City of Pompano Beach – DRC-Pre Application Comments

Project Name: Archi-One

Project Address: 14200 North Federal Hwy. Pompano Bch FL.

Process Number: PZ22-12000039

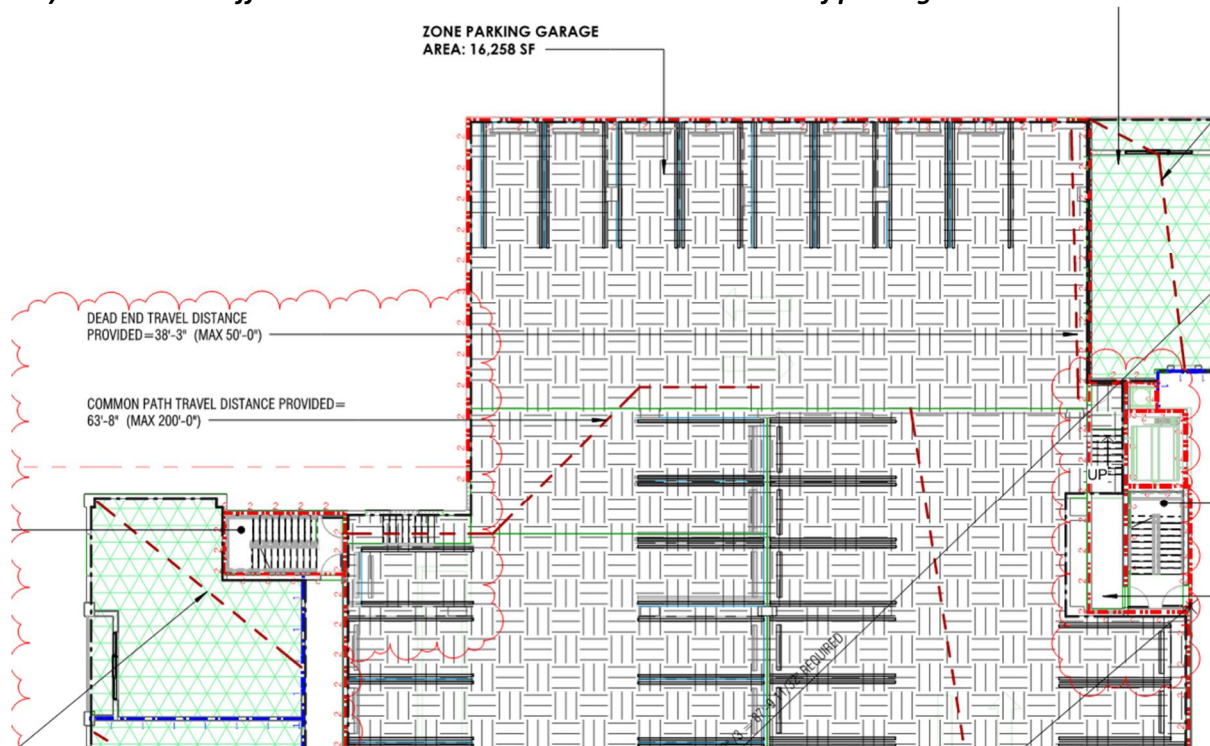
() Life Safety pages: appears that travel distances, dead end travel and common path of travel have been exceeded as per NFPA 101 2018 Edition Chapter 30 New Apartments.

() Garage all levels: dead end travel exceeded.

Additional entrances to Stair 1 & Stair 3 have been added to the garage in order to reduce travel distance, common path and dead end conditions. An additional Life Safety plan has been added (LS-1.1) to show the different conditions in the second and third level of parking.

Additional entrances to Stair 1 & Stair 3 have been added to the garage in order to reduce travel distance, common path and dead end conditions. An additional Life Safety plan has been added (LS-1.1) to show the different conditions in the second and third level of parking.

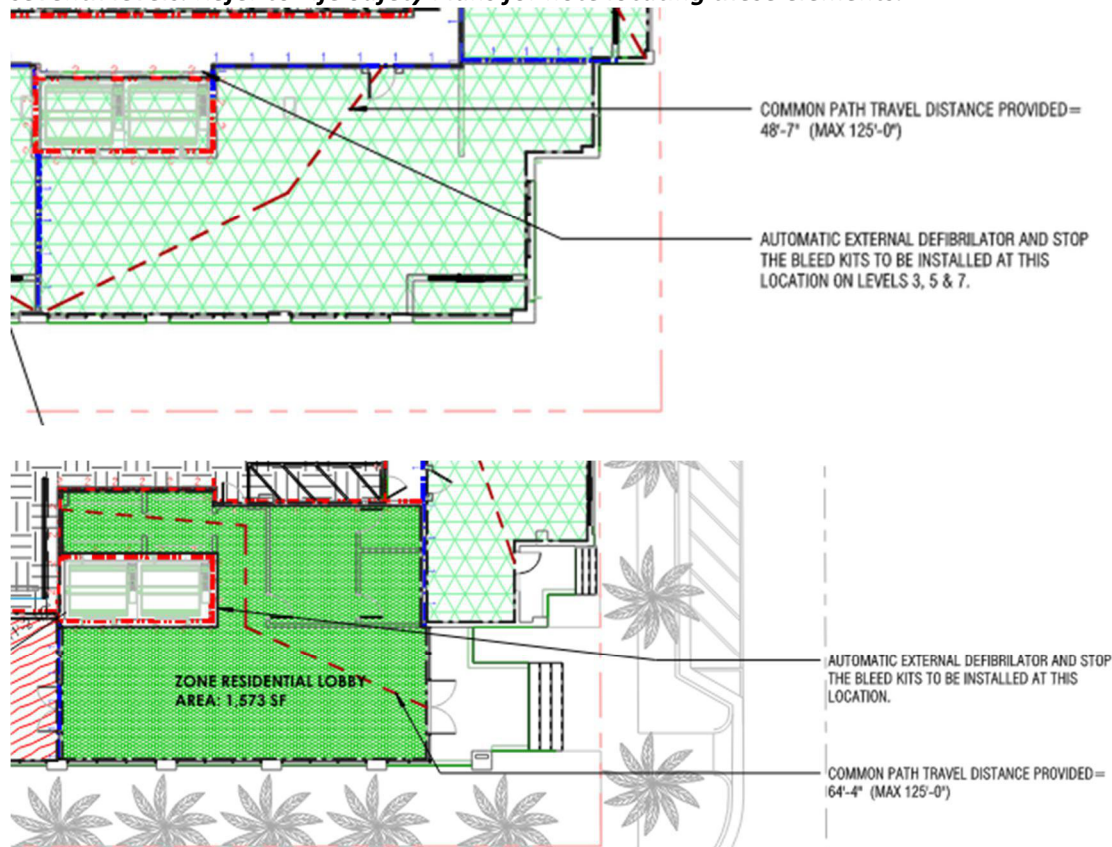
() F-121.2.7.1 Multi story occupancies listed above shall place an AED and SBK on every other floor beginning on the first floor. The AED and SBK shall be placed near the elevator(s) beginning in the first-floor lobby (first floor, third floor, fifth floor etc.)

Requested AED and SBK elements will be located adjacent to elevator landings at first, third, fifth and seventh levels. Refer to Life Safety Plans for note locating these elements.

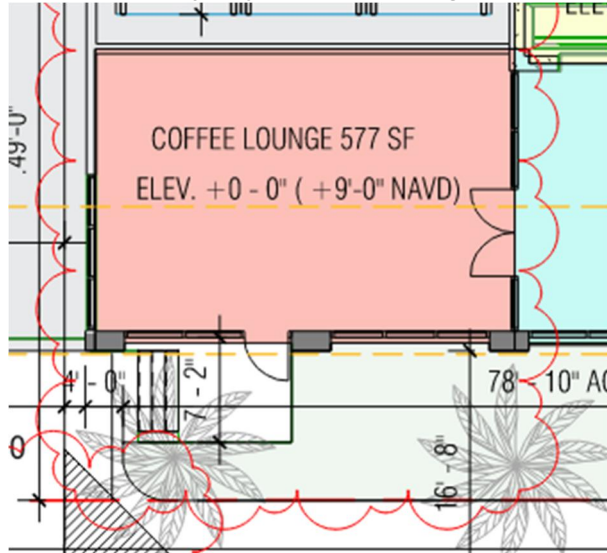
6. The previous comment pertaining to the “Coffee Lounge” doors needs further clarification. The response stated that the Coffee Lounge is proposed to be accessed from the building lobby... Please show the doorway/access between the Coffee House and the lobby.

A set of double doors have been added connecting the resident Coffee Lounge to the building lobby. An additional door has been added at the storefront providing direct egress from the space to the outside. A set of steps connect this egress door to the sidewalk.

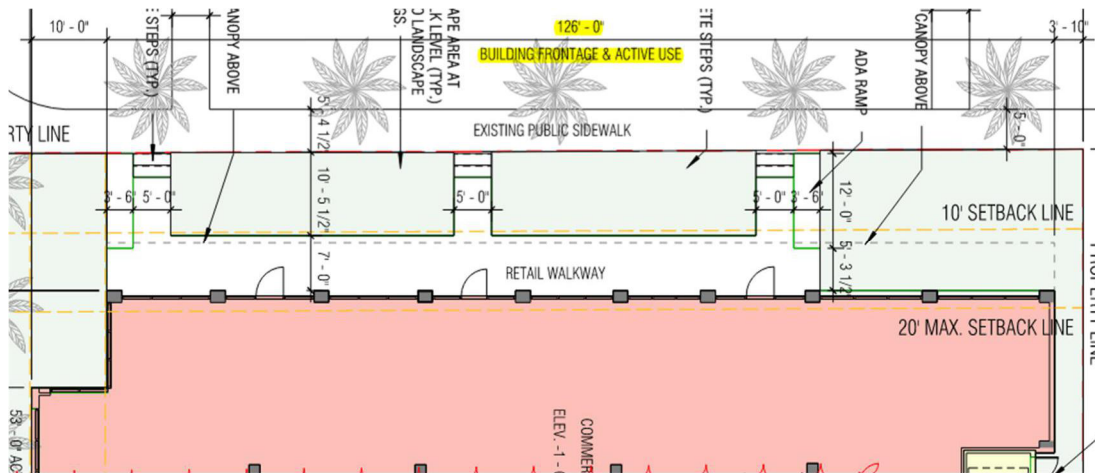
8. The minimum required Building Frontage for North Federal Hwy is 90% of the length of the property along that right-of-way, or 126 feet minimum. The proposed outdoor courtyard area is not considered building frontage and cannot be counted toward the requirement.

Building frontage along N Federal Highway has been widened in order for the building to comply with the 126'-0" minimum requirement. This façade had to be pushed back further into the setback in order to maintain compliance with the minimum permeable area requirement. Regardless of this change, the frontage remains within the maximum setback requirement.

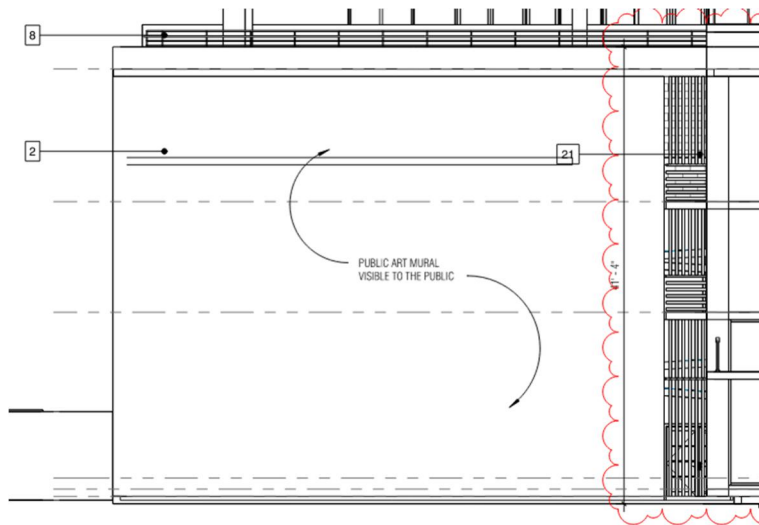
14. For Density Bonus option #1, identify whether a piece of artwork or a fee will be provided to satisfy the requirement of the Bonus.

A piece of artwork valued at 1% of the project's construction costs or a maximum of \$250,000 will be added to the project displayed on exterior walls facing N Federal highway. A note showing location of artwork has been added to West elevation. Lot Occupation table includes this statement as well.

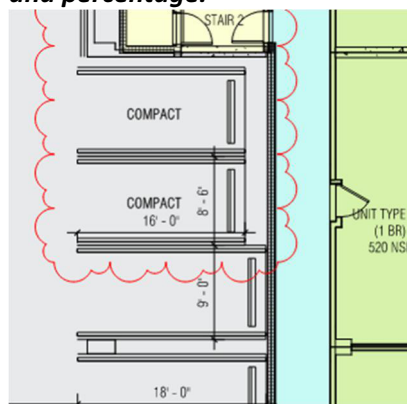
15. Identify the line that appears on the site plan along the south side, between the building and the south right-of-way line that extends from approximately 18 feet east of the west right-of-way line to the edge of pavement at NE 22 Ave.

Line has been deleted from plans.

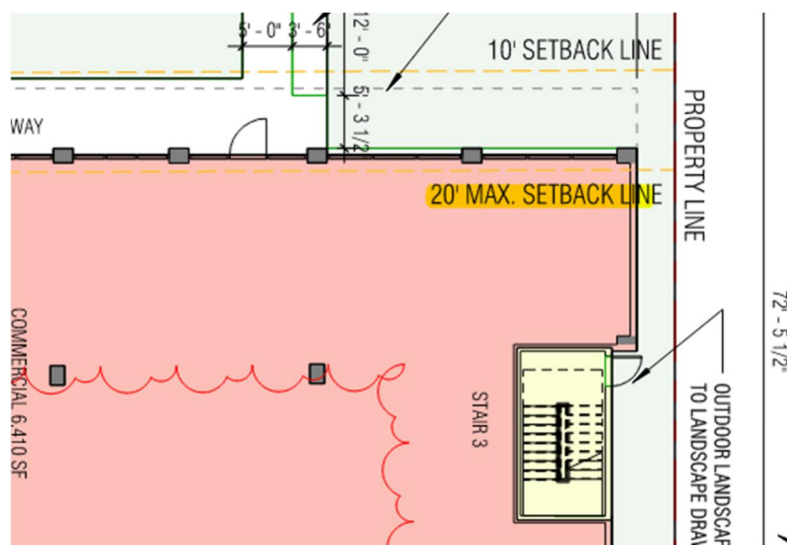
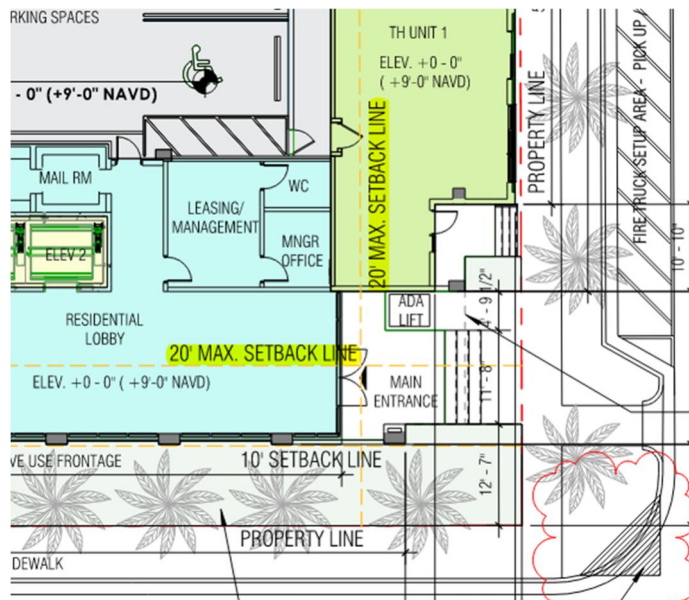
17. The site plan shows a 10-foot setback line on the three street fronts. The maximum front and street side setbacks in the Core Sub-Area is 20 feet. Revise the site plan to provide the correct setback.

Maximum 20' setback line has been added to the three sides of the property facing a street on the siteplan. Building Setback table on Project data chart has been updated to show the maximum setback as well.

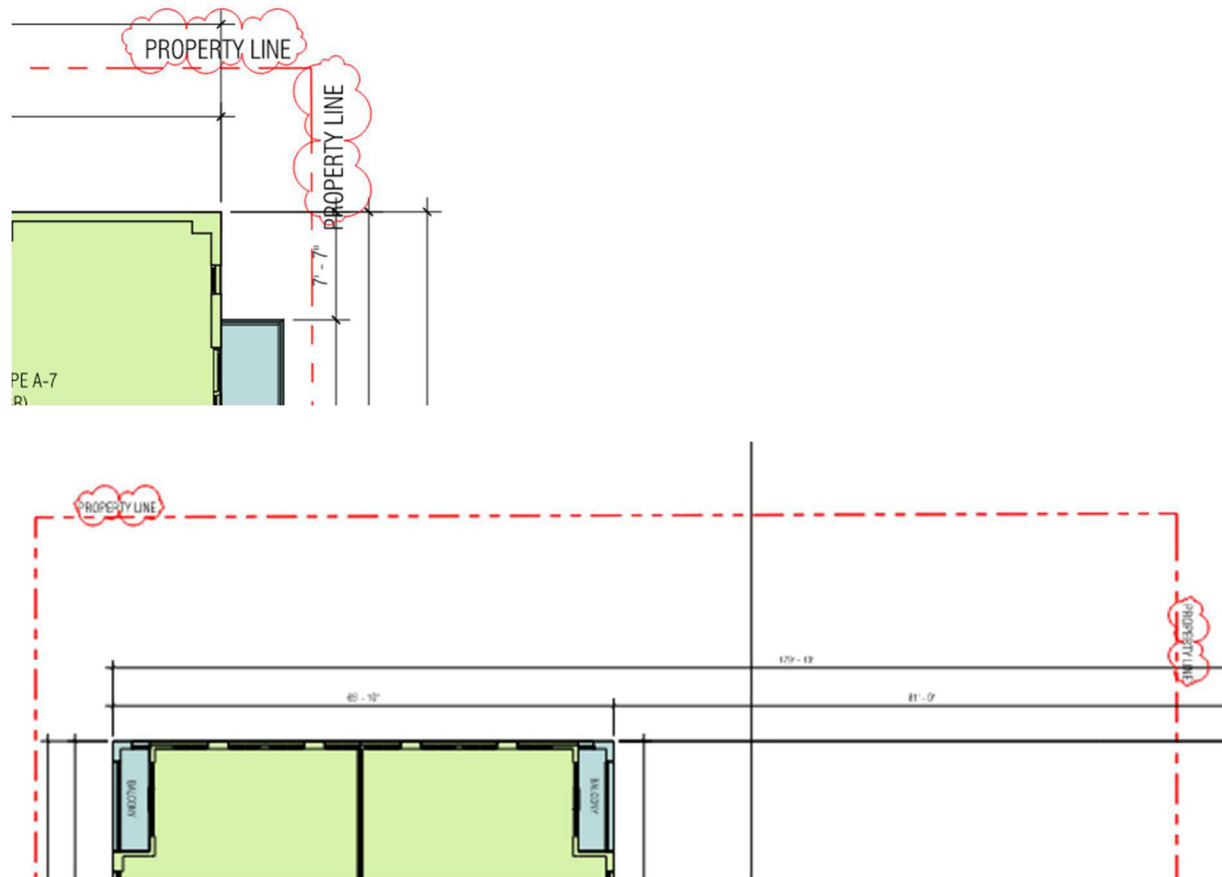
18. Show the property lines on all floor level plans, with proposed building setbacks to property lines for each level.

Property lines and notes labeling all property lines have been added to plans at all levels.

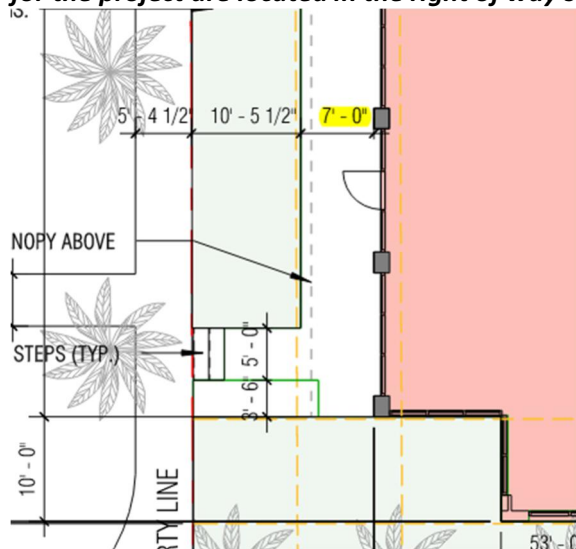
20. In the TO/EOD, sidewalks in the right-of-way are permitted to be 5 feet wide. Walkways/sidewalks on private property must be a minimum 7 feet wide in commercial and mixed-use Zoning districts, pursuant to Section 155.5101.1.3.a.i. Revise the plans to provide the minimum required width for all sidewalks and walkways.

Walkway at N. Federal Hwy has been increased in width to 7'-0" at it's narrowest. All other sidewalk for the project are located in the right of way so they are a minimum of 5'-0".

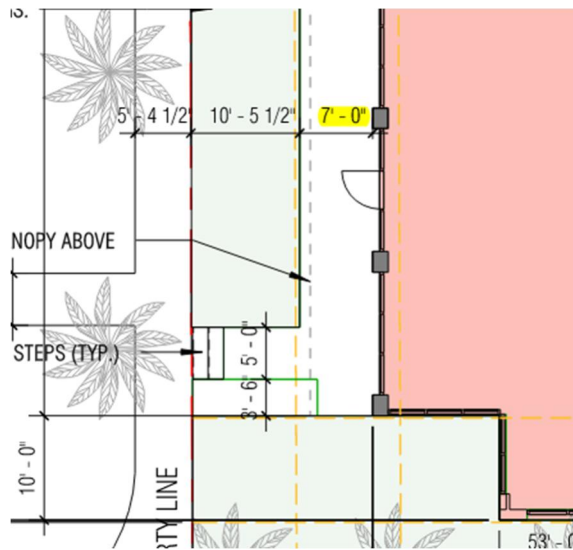
21. On the Site Plan, sheet A-01, the "Retail Walkway" at the west side of the building has a dimension of 5 feet 8 inches from the edge of the walkway at the planters to the face of the building. It appears that the building columns protrude into the walkway. Revise the dimension for the walkway width from the outer edge of the walkway at planters to the face of the columns, which appears to be the narrowest width of the walkway.

Dimension has been revised to show the condition at the narrowest width for the walkway. Width is now 7'-0".

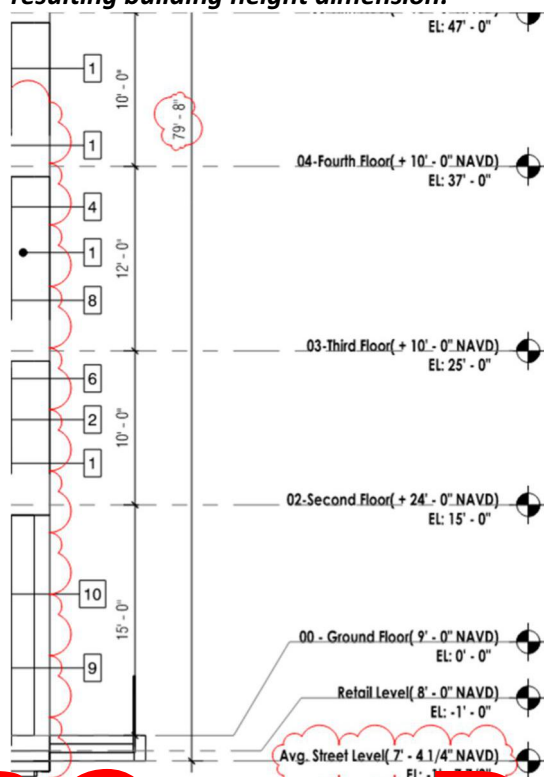
22. Verify that the dashed line that denotes average street level is consistent with the average elevation of the finished grade at the front of the proposed structure. If not, revise elevations to show the average elevation of the finish grade at the front of the structure. Section 155.9401.G identifies the measurement of building height as the measurement of the vertical distance from the average elevation of the existing finished grade at the front of the structure to the top of the roof for a flat roof.

Average street level has been recalculated to average out the elevation at the front of the structure as per the elevation points shown on the civil plans. Average street level went from 7'-0" NAVD to 7'-4 1/2" NAVD. Elevations have been updated accordingly showing the updated street level as well as the resulting building height dimension.
